CITY COUNCIL AGENDA ITEM
CITY OF SHORELINE, WASHINGTON

AGENDA TITLE:	Adopting Ordinance No. 871 - Amending Certain Sections of the Shoreline Development Code to Provide for Townhouse Design Standards
DEPARTMENT:	Planning & Community Development
PRESENTED BY:	Catie Lee, AICP, Associate Planner Nora Gierloff, AICP, Planning Manager Rachael Markle, AICP, Director
ACTION:	<input checked="" type="checkbox"/> Ordinance <input type="checkbox"/> Resolution <input type="checkbox"/> Motion <input type="checkbox"/> Discussion <input type="checkbox"/> Public Hearing

Amended illustration and new illustration for 20.50.160(B)(1), uses term “Right-of-Way”:

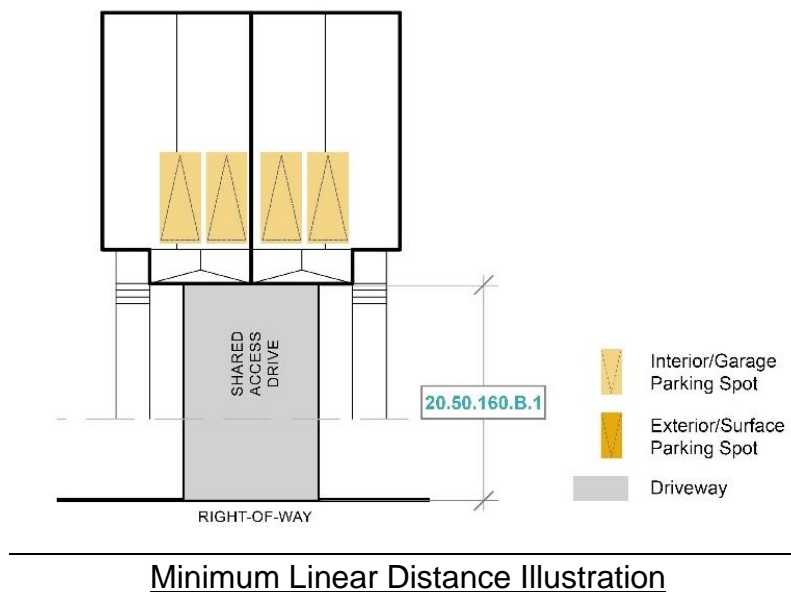
Justification: This illustration needs to be updated to change the words “Primary Street” to “Right-of-Way” for accuracy and consistency with the other illustrations. Planning Commission illustration for 20.50.160(B)(1), uses term “Primary Street”:

Amended illustration and new illustration for 20.50.160(D)(2):

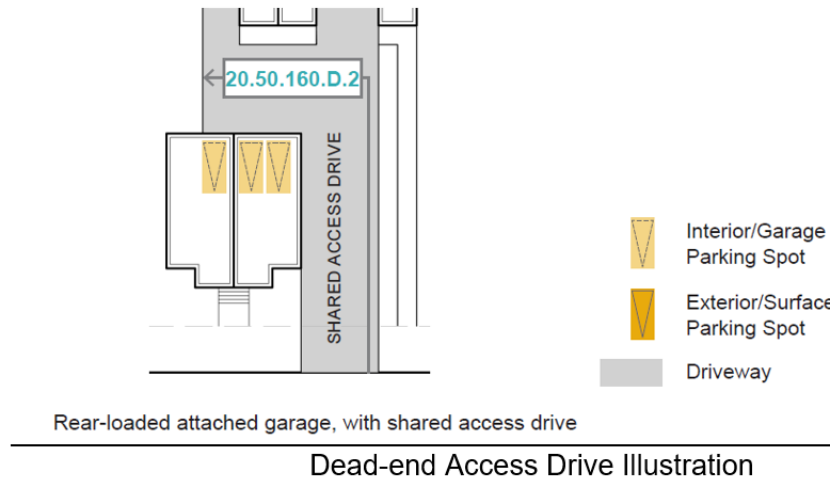
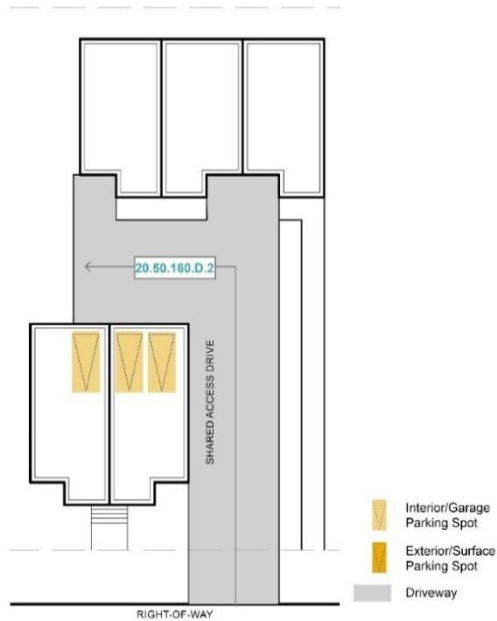
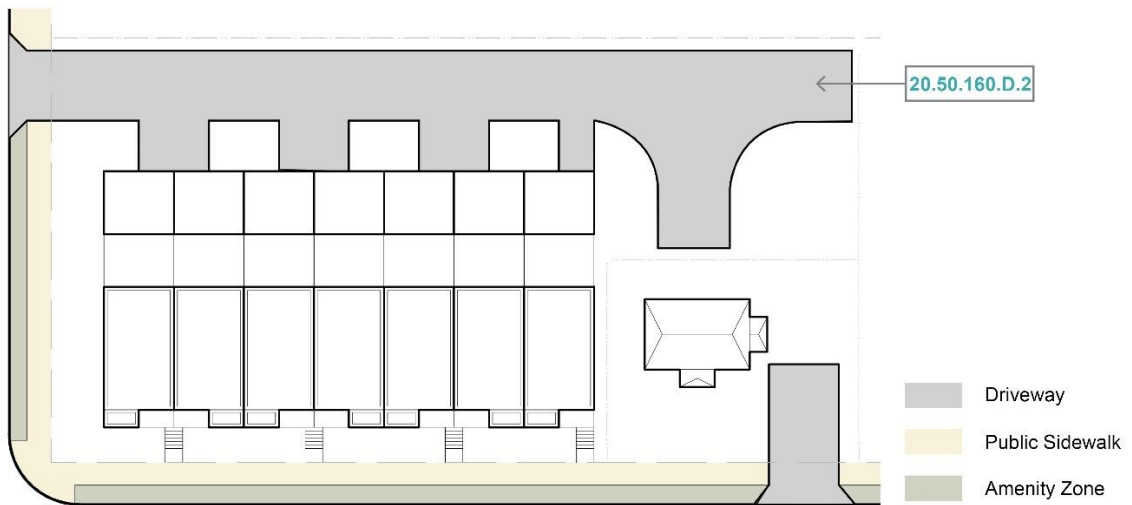
Justification: The Planning Commission illustration for a dead-end access drive is not clear in its depiction of the proposed code standard. The amended illustration clarifies that a turnaround facility is not needed in this instance since the measurement of the access drive from the curb to its furthest extent is less than 150 feet. A new illustration is proposed to show a scenario that requires a turnaround facility. In this example, the distance from the curb to the furthest extent of driveway without the turnaround facility is 170 feet. The turnaround facility depicted is based on a draft Standard Detail produced by the Public Works Department in the forthcoming update to the Engineering Development Manual (“EDM”) that will take place in March 2020. The EDM is a technical manual and the most appropriate document to provide such engineering details. The illustration shown here depicts the basic concept but for the actual specifications the designer needs to reference the EDM.

Dead-end Access Drive Illustration 1: Access drive is less than 150 feet, so a turnaround facility is not required

Amended illustrations for 20.50.160(D)(4) and (5):

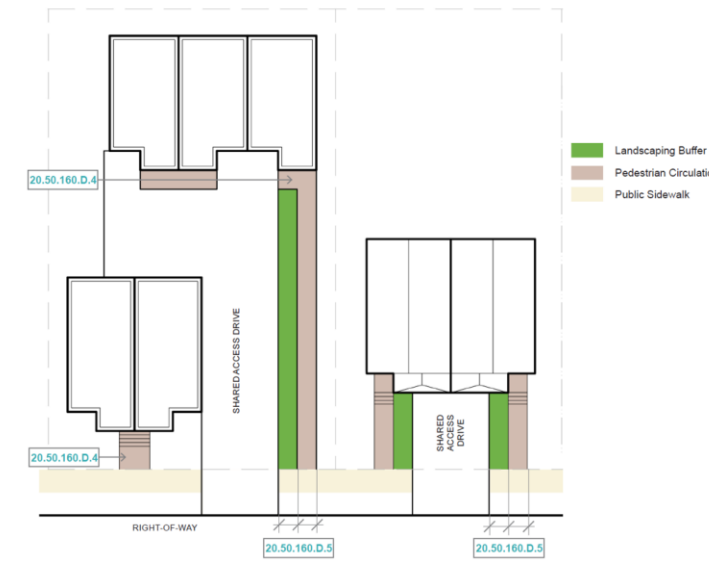
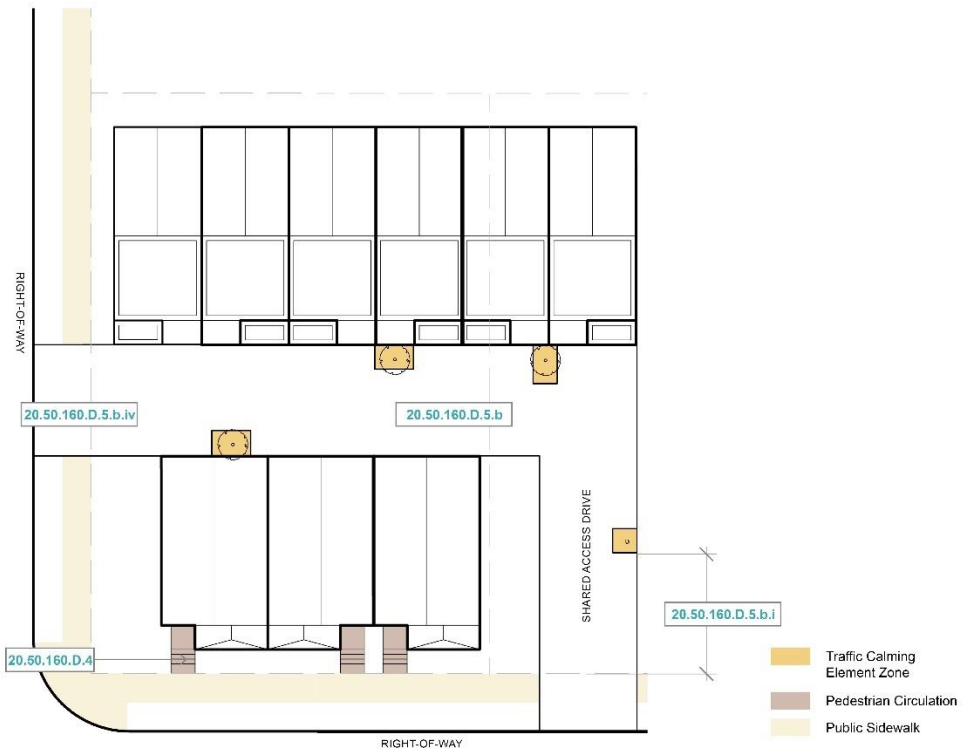
Justification: The second illustration from the Planning Commission recommended code for site access and circulation shows a planter box or bollard immediately as a vehicle would turn onto the site. The amended second illustration removes this element to allow for turning onto the site. The only change to the first illustration is placement of the legend.

Amended illustrations for 20.50.160(G):

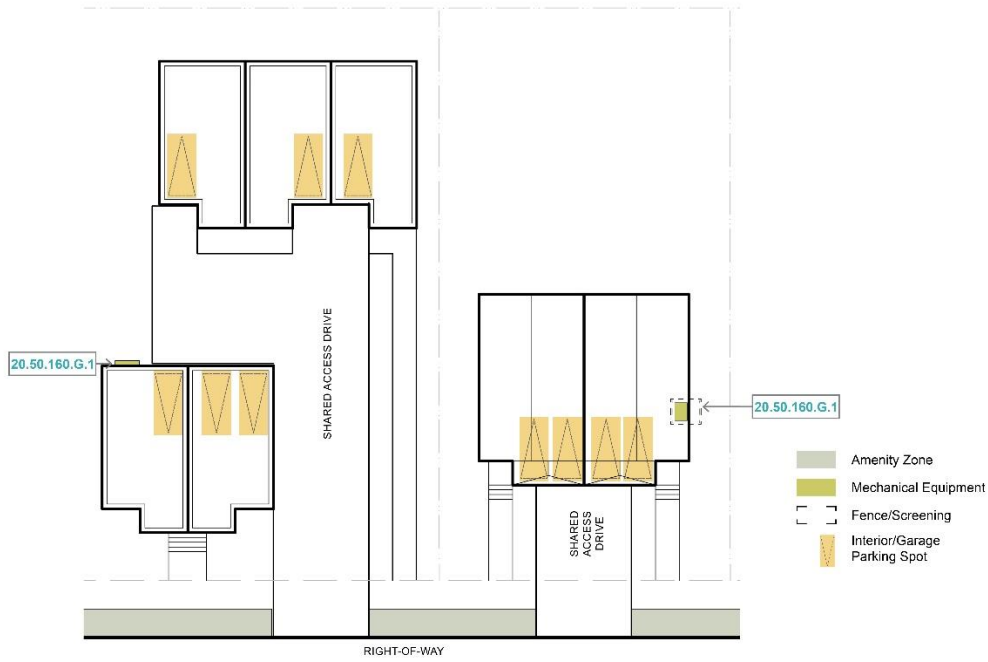
Justification: The first illustration from the Planning Commission illustrations for utility and mechanical equipment shows mechanical equipment projecting into a five-foot setback larger than the size allowed by code. The second illustration from the Planning Commission illustrations for utility and mechanical equipment is not clear that screening is provided. The amended first illustration shows code compliant mechanical equipment that is out of the setback and is screened. The amended second illustration contains screening that is called out in the legend.

Planning Commission illustration for 20.50.160(H):

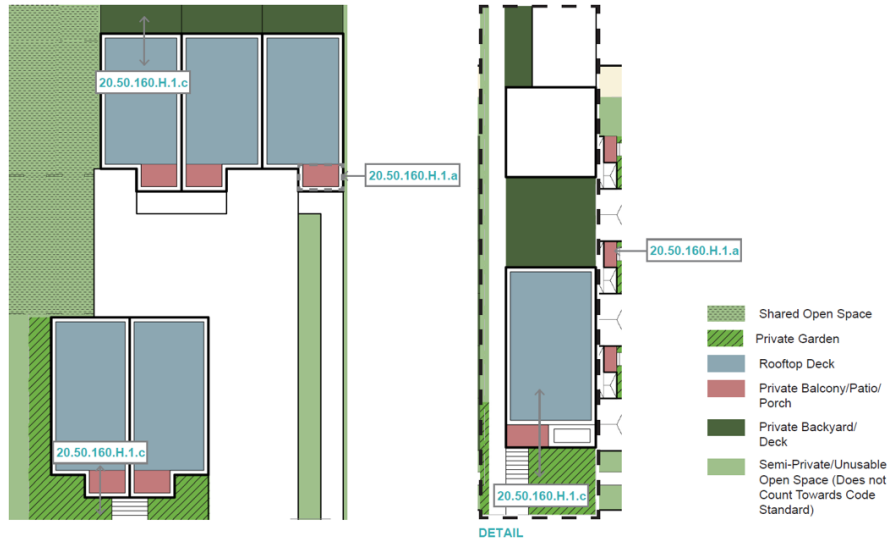
Justification: The Planning Commission illustrations contain inaccurate references to “20.50.160.H.1.c” which does not exist. The amended illustrations contain the correct reference to “20.50.H.1.a” and “20.50.H.1.a.iii.”

Building Modulation, Massing and Articulation Illustration 1

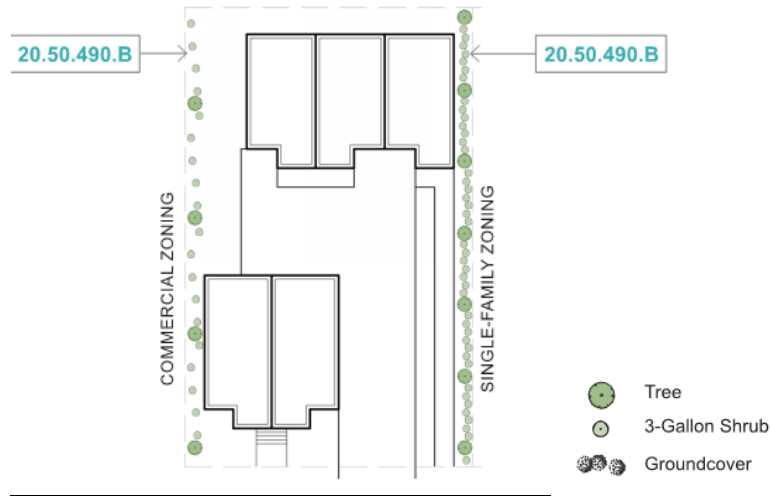
Justification: The Planning Commission illustration omitted the landscaping symbol from the legend. The amended illustration includes the landscaping symbol on the legend.

Site Configuration Illustration 1

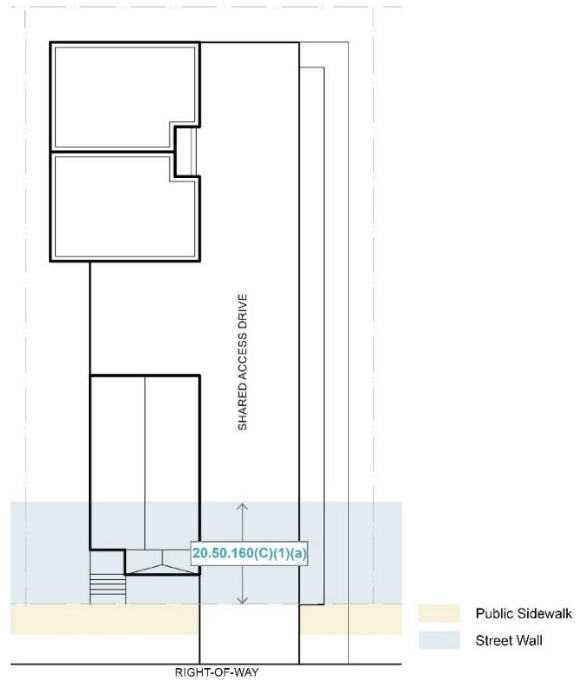
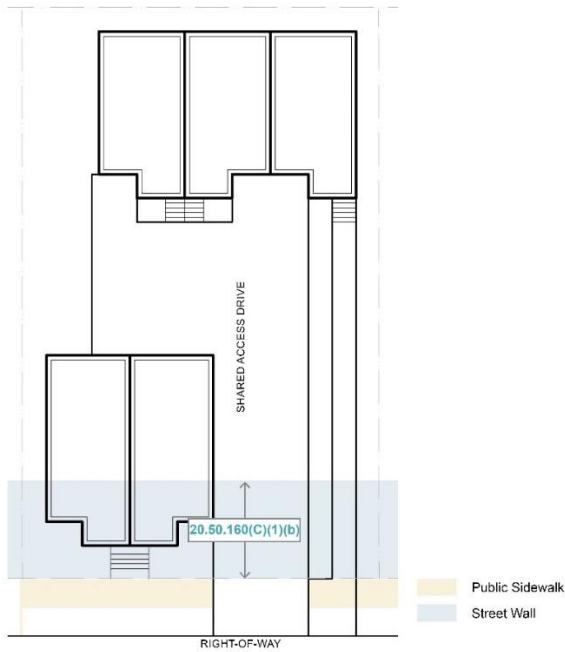
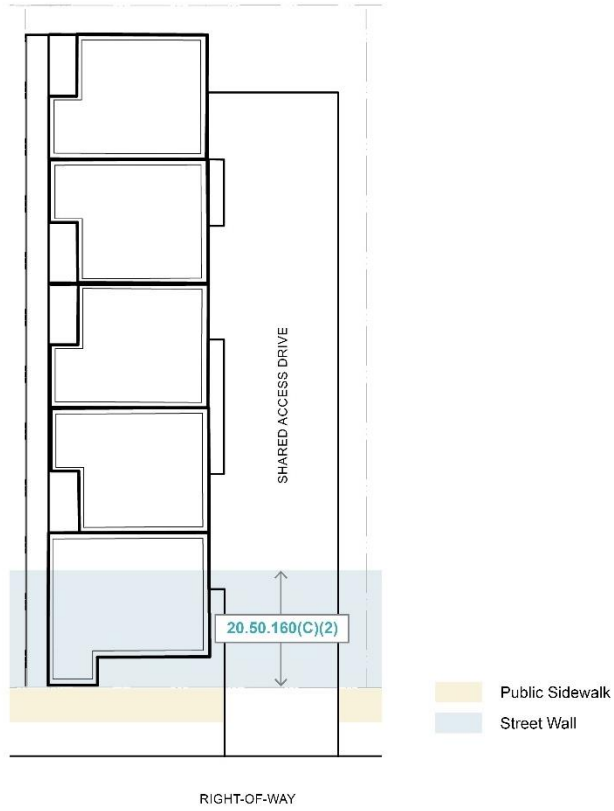
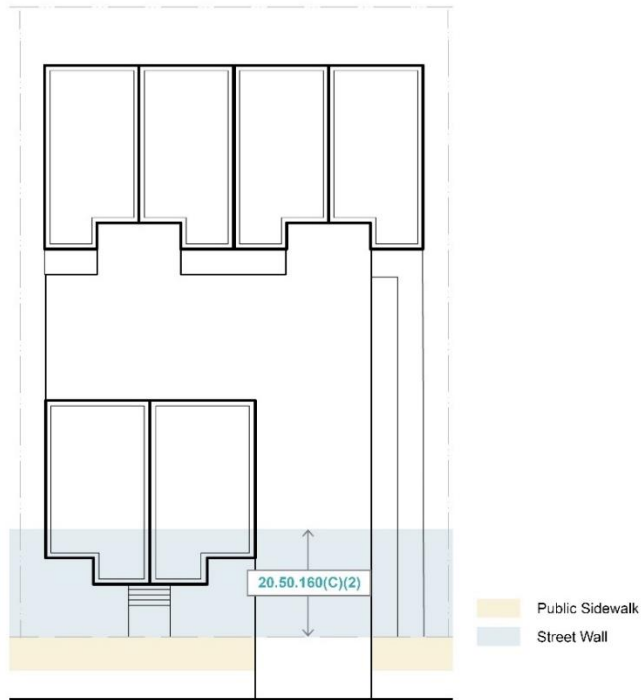
Justification: The Planning Commission recommended this language related to site configuration at the October 3, 2019 Public Hearing so illustrations were not available at that time depicting the code standard. Since that time, staff coordinated with the City's consultant on this project to develop illustrations that demonstrate the standard.

I move that the Planning Commission's recommendation be amended to include the four (4) site configuration illustrations as set forth in Section B of the January 6, 2020 Staff Report for visual support of SMC 20.50.160(C) Site Configuration.

City staff amendment for 20.50.490(B) with change highlighted and Illustration 2 added:

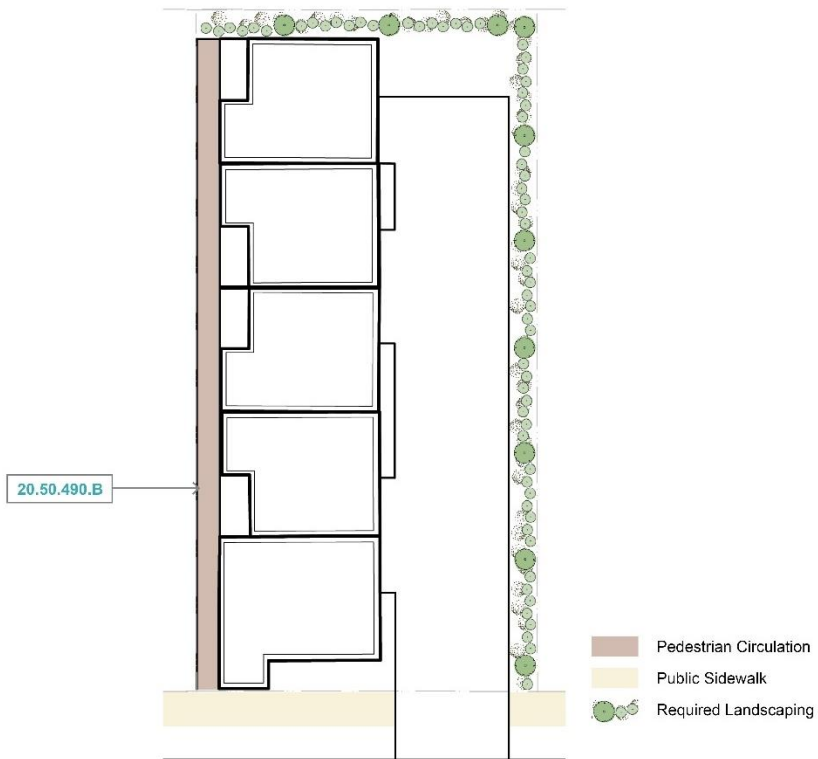
Justification: Staff is recommending this amendment based on the Planning Commission recommendation for site configuration in MUR-45’. If you assume a 60-foot wide lot in MUR-45’ with a five-foot setback on each side, a 20-foot wide access drive and 4-foot walkway, the townhouses will only be 26 feet deep, which is not a typical depth for townhouses. Therefore, staff is recommending the interior landscaping requirement be waived on the side that does not abut vehicular access. That allows another five-feet to achieve a townhouse width of 31 feet which is more typical.

I move that the Planning Commission's recommendation for SMC 20.50.490(B) Landscaping Standards, be amended to include the following waiver language at the end of the existing paragraph:

Planning Commission recommendation for 20.50.160(C)(1)(a), and associated illustration:

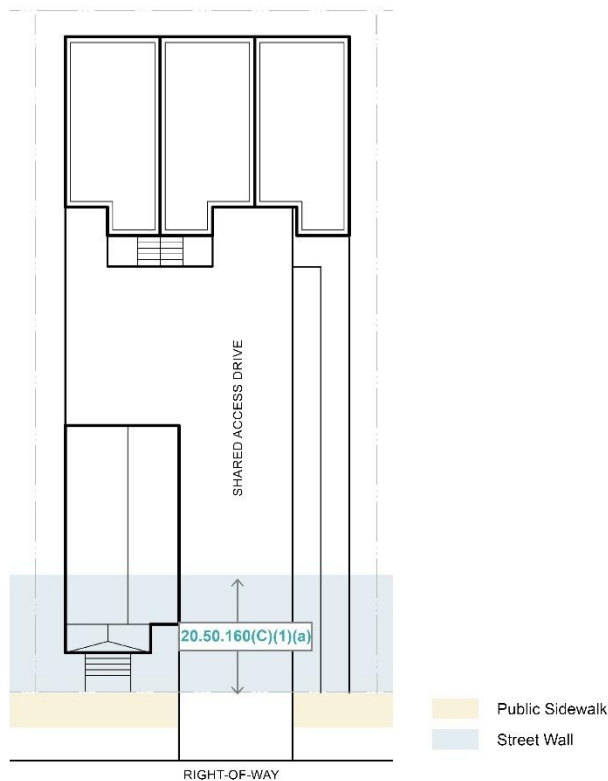
Justification: Reducing the proposed requirement from 30% to 25% of units in all zoning districts except MUR-45' that have to be within 25 feet of the front property line on lots up to 70 feet wide allows more units to be built on the site, although they will be skinnier. Note that in the 25% illustration provided, which depicts one detached unit in front and four units tucked behind, the front unit is 22 feet wide and the rear units are 16 feet wide. This is in contrast with the 30% illustration in which all units are 22 feet wide. More units are beneficial in achieving the purpose of higher density development in the MUR-35' zoning district but could also lead to undesirable outcomes such as the perpendicular-orientated, linear configuration development. This configuration is not shown in the illustration but is still feasible with a requirement of 25%.

a. On lots up to 70 feet in width, at least ~~30~~ 25 percent of units within a site shall be located between the front property line and a 25-foot distance from the property line.
